**Fire Protection Upgrades
Halifax Elementary School
464 Plymouth Street
Halifax, MA 02338**

**Habeeb & Associates Architects
H&A Job No. 1614.01**

**ADDENDUM NO. 03
February 4, 2019**

C3 BUILDING SECTION - GYMNASIUM
1/8" = 1'-0"

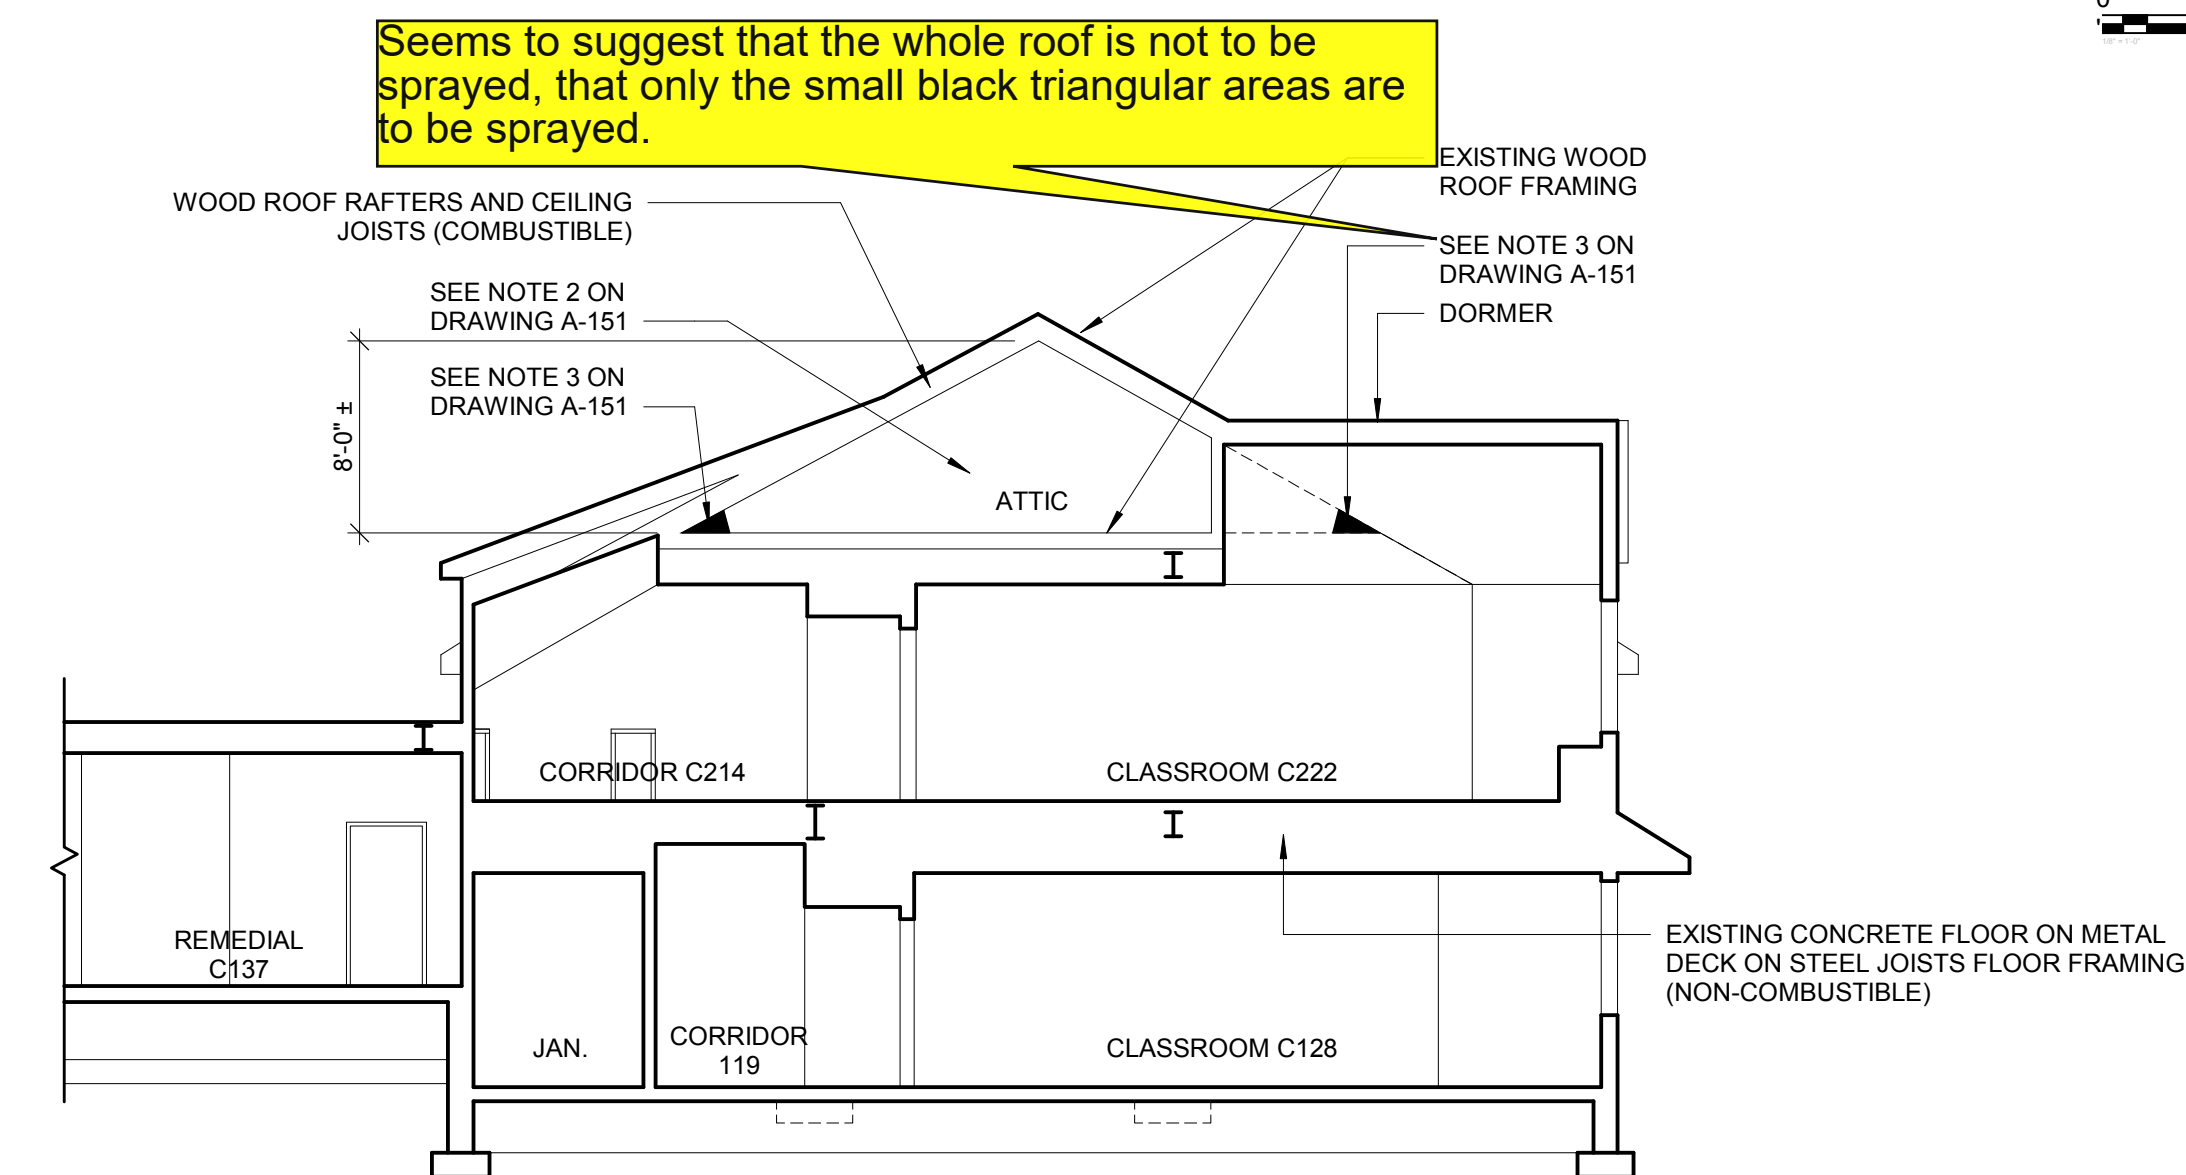
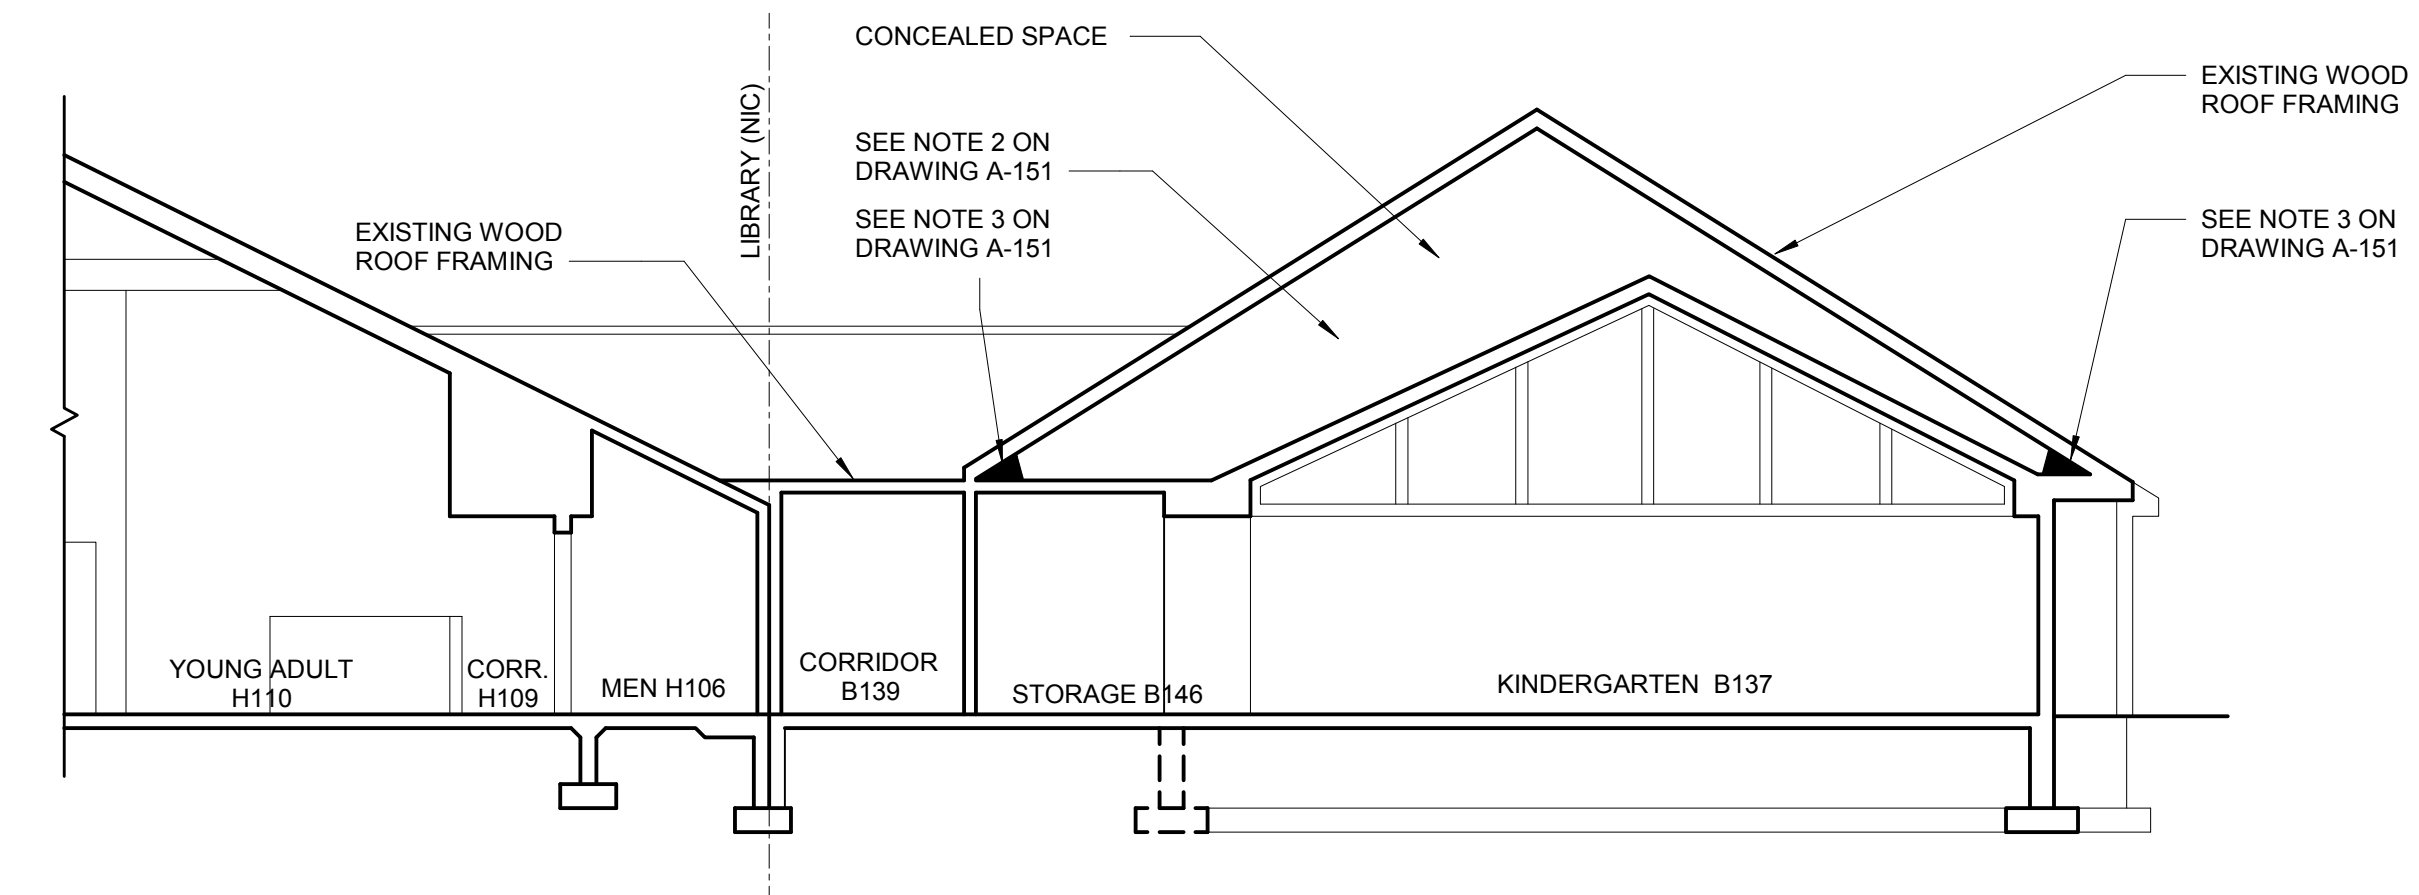
4. **QUESTION:** Regarding the comment highlighted in yellow in Sheet Number A-300 ATTIC SECTIONS, are we to understand that the whole roof is not to be sprayed, that only the small black triangular areas are to be sprayed? If so then is it the foam in SPECIFICATION 2.02 or SPECIFICATION 2.03? Additionally what is the R-VALUE and what are the dimensions for installation of this foam?

RESPONSE: The whole roof does not need to be sprayed. Just the areas along the eaves shown in the black triangular areas and as shown on the attached sketch SK-1.
